SECTION 4.15 ASSESSMENT REPORT
Environmental Planning & Assessment Act 1979

| File No: | DA/964/2022 |

| Subject Property: | Lot 35 DP 8884, 14 Windermere Avenue, NORTHMEAD NSW 2152 |
| Proposal: | Demolition of existing structures, tree removal and construction of a part two and part three storey, 88 place Child Care Facility. |

Figure 12: Site Plan. Source: Group Janssen Design.

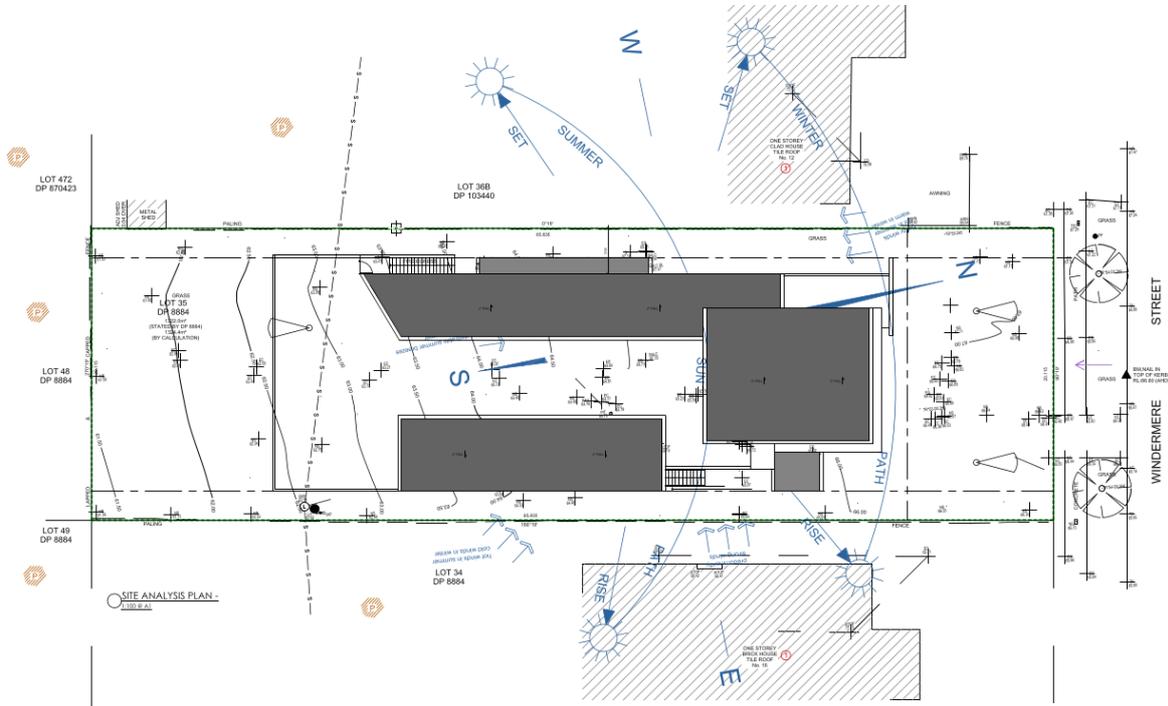
4. The ground floor is dominated by carparking including the front setback area comprising open carparking with a relatively small amount of landscaping. The external car parking does not comply with the DCP's requirement that parking be setback 5m from the frontage.

5. The pedestrian entrance to the building is deep within the site and not visible from the street. It comprises a long and narrow pathway down the side of the building adjacent to the western boundary. Whilst there is space for landscaping adjacent to the boundary, the length and poor visibility of the entry is not ideal. The location of the entry also has the potential to impact on the privacy of the residential property to the west.

6. The proposal to split the building into two entities separated by the ground floor parking level is not supported by the Panel as it results in access and safety concerns.

Figure 15: Proposed Height breach outlined in red. Source: Janssen Designs.

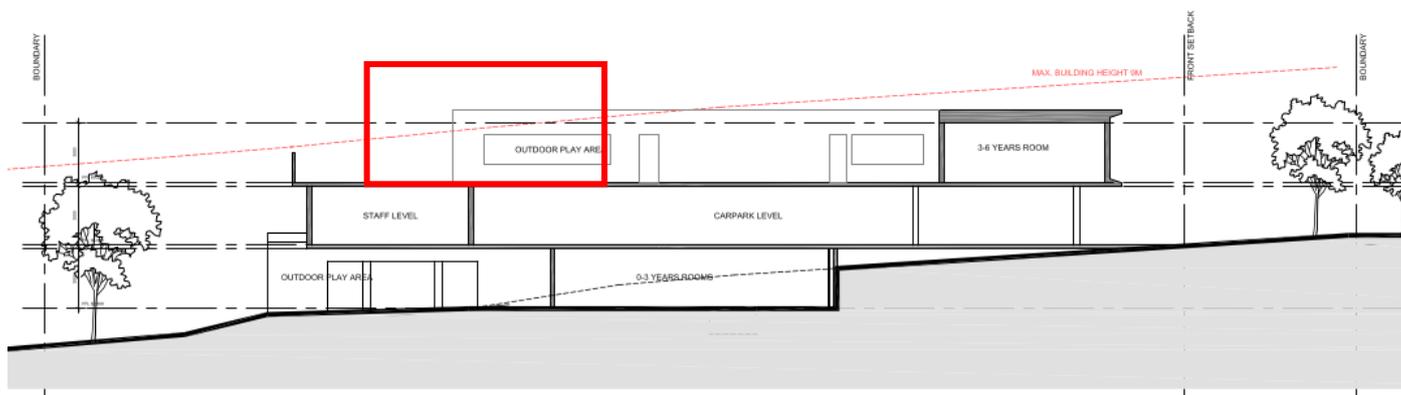
Comment: As shown in **Figure 15**, the elements of the proposed building which exceed the control are largely toward the Rear of the proposed First floor.

The encroachment of the first-floor element towards the rear results in poor amenity towards the lower ground floor internal play areas. Most notably the 0–2-year-old indoor playroom will be located under an undercroft resulting in poor solar amenity and ventilation.

Further, the height of the development leads to the shadowing of the rear lower ground outdoor play area as shown in **Figure 9**.
